PREAMBLE TO AMENDMENT TO MOTOR VEHICLE SAFETY STANDARD NO.201

Occupant Protection in Interior Impact—Passenger Cars

PREAMBLE TO AMENDMENTS TO MOTOR VEHICLE SAFETY STANDARDS NO. 201

Occupant Protection in Interior Impact

Figure 1—Test Fixture for Clamped Specimens

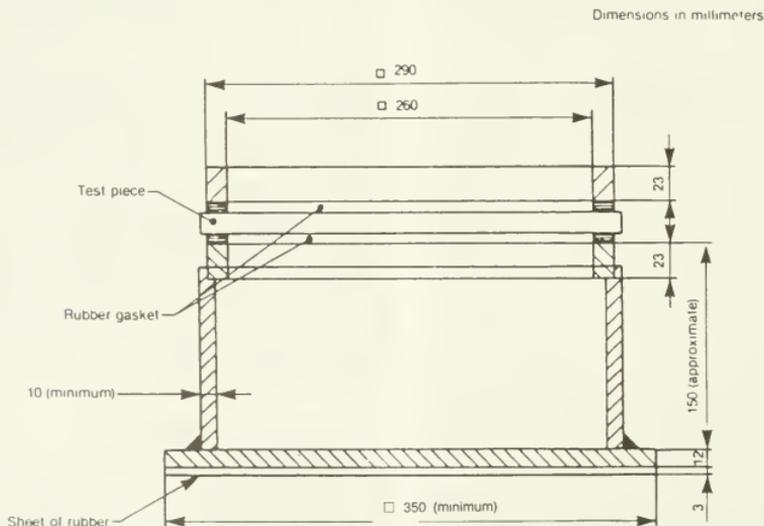
Paragraph (e) is added after paragraph (d) of S5.1.2.4 as follows:

(e) The glass-plastic glazing specimen tested in accordance with Test No. 26 shall be clamped in the test fixture in Figure 1 of this standard in the manner shown in that figure. The clamping gasket shall be made of rubber 3 millimeters (mm) thick of hardness 50 IRHD (International Rubber Hardness Degrees), plus or minus five degrees. Movement of the test specimen, measured after the test, shall not exceed 2 mm at any point along the inside periphery of the fixture. Movement of the test specimen beyond the 2 mm limit shall be considered an incomplete test, not a test failure. A specimen used in such an incomplete test shall not be retested.

Figure 1 is added at the end of Federal Motor Vehicle Safety Standard No. 205.

Figure 1—Test Fixture for Clamped Specimens

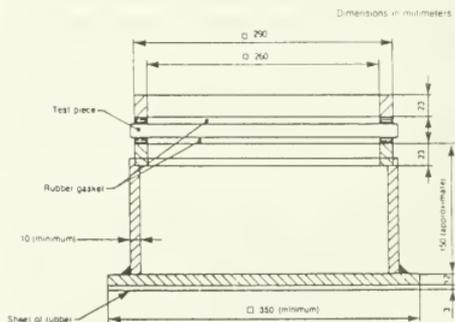
[(e)(1) Except as provided in S5.1.2.9(e)(2), glass-plastic glazing specimens tested in accordance with Test Nos. 9, 12 and 26 shall be clamped in the test fixture in Figure 1 of this standard in the manner shown in that figure. The clamping gasket shall be made of rubber 3 millimeters (mm) thick of hardness 50 IRHD (International Rubber Hardness Degrees), plus or minus five degrees. Movement of the test specimen, measured after the test, shall not exceed 2 mm at any point along the inside periphery of the fixture. Movement of the test specimen beyond the 2 mm limit shall be considered an incomplete test, not a test failure. A specimen used in such an incomplete test shall not be retested.

(2) At the option of the manufacturer, glass-plastic glazing specimens tested in accordance with Test Nos. 9 and 12 may be tested unclamped. Such specimens shall be tested using the fixture in Figure 1 of the standard, including the upper frame (unclamped) which holds the specimen in place.

Figure 4—USE OF CLEARANCE TEST BLOCK TO DETERMINE HAND/ARM ACCESS

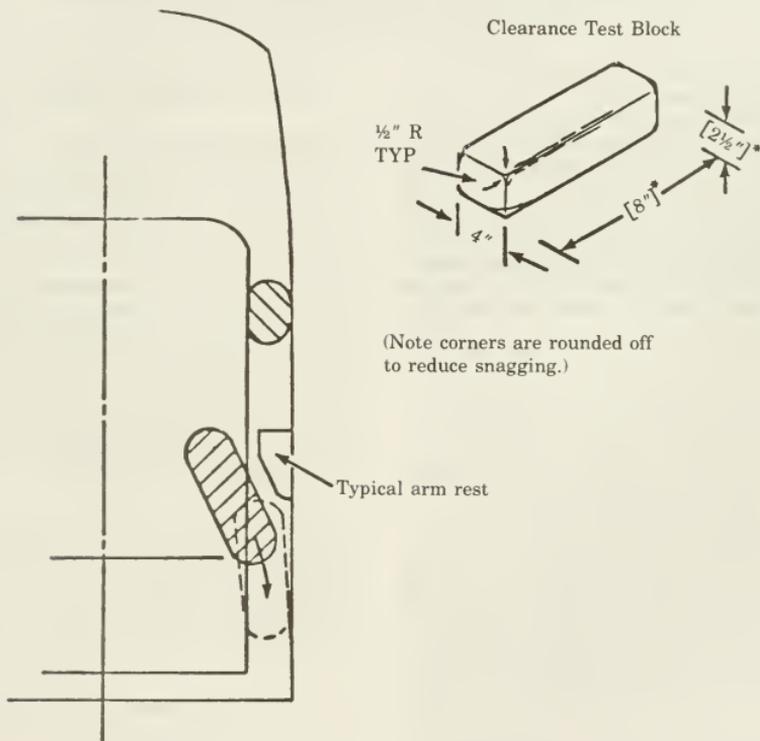
13. Figure 4 of this standard is modified as follows:
